Interactive comment on “Open check dams and large wood: head losses and release conditions” by Guillaume Piton et al.

Guillaume Piton et al.

Received and published: 27 July 2020

Fig. 1. Figure 1: Froude number with and without LW for each dam type

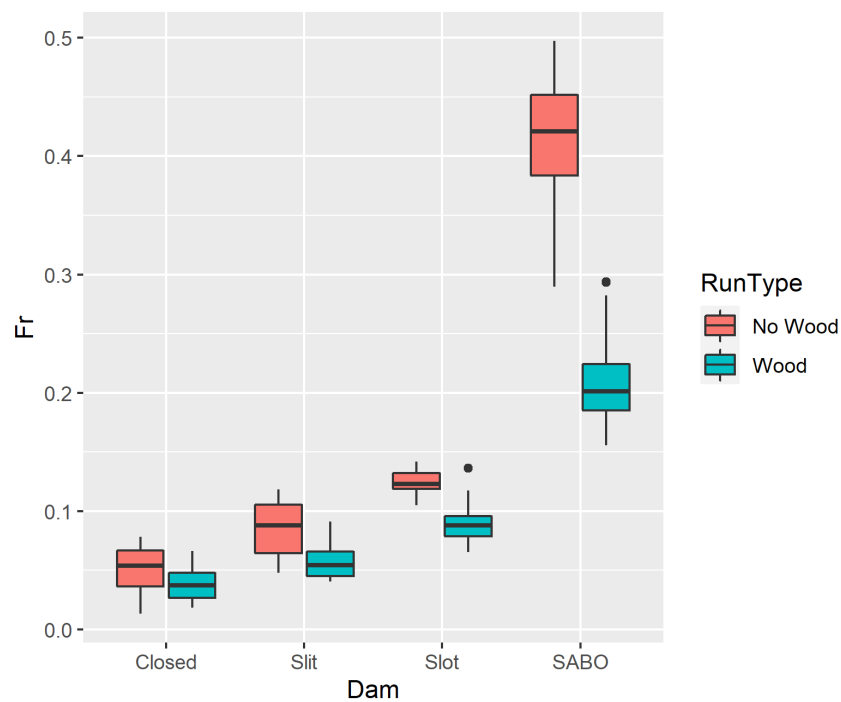
Reviewer Comment: 24. L98: The authors state a range of flow Froude number F between 0.01 and 0.3. $F = 0.01$ this is very small; is this a common value at check dams - in particular when the authors stated in L80 that the flow Froude number is expected to be larger at check-dams compared to reservoir dams. Please discuss.

Froude number with LW varies between 0.01 and 0.3. It was specifically low for the closed dam, which is quite similar to a dam reservoir structure. The bigger the opening, the higher the Froude number as shown in Figure 1.

We know from other experiments with the same flume setting that the Froude number without structure would be close from 0.7 but the presence of open check dams tend to create a significant backwater and decrease of the Froude Number directly upstream.

In the revised version of the paper, the following mention will be added in the Material and methods section: “The mean value \pm standard deviation of the Froude number was 0.04 ± 0.01 , 0.06 ± 0.02 , 0.1 ± 0.02 and 0.24 ± 0.08 for the closed, slit, slot and Sabo dam, respectively (see section 3.2 for dams’ features).”
